HYUNDAI Technical Service Bulletin

GROUP HVAC	NUMBER 17-HA-004
DATE October, 2017	MODEL(S) Sonata (LFa)

SUBJECT: A/C EVAPORATOR DRAIN HOSE LENGTH INFORMATION

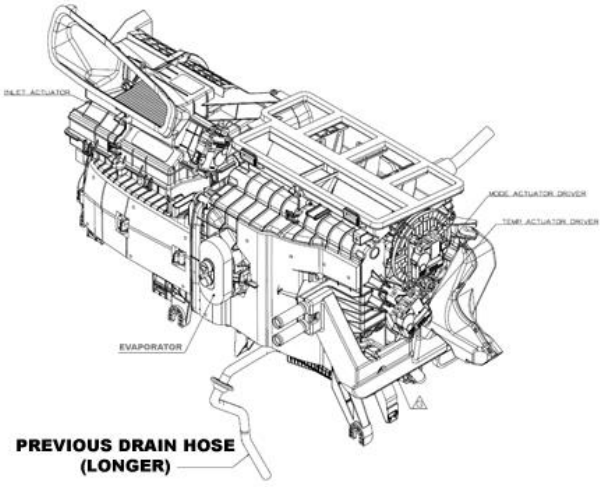
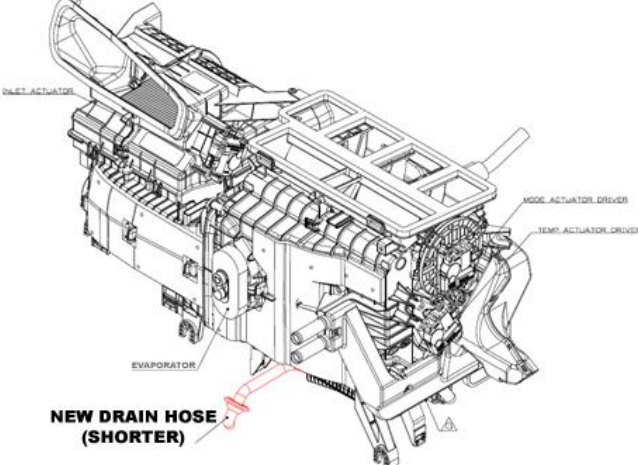
Description: This bulletin provides information regarding the A/C evaporator drain hose length specification change on certain Sonata (LFa) vehicles.

Part Name	Part Number	
	Previous	New
Drain Hose	 <p>PREVIOUS DRAIN HOSE (LONGER)</p> <p>Drain Hose Length: 461mm (Total)</p>	 <p>NEW DRAIN HOSE (SHORTER)</p> <p>Drain Hose Length: 226mm (Total)</p>
	97284-C2000 (Drain Hose Part Number Has Not Changed)

Take note of these length changes as being normal whenever a vehicle is being inspected.
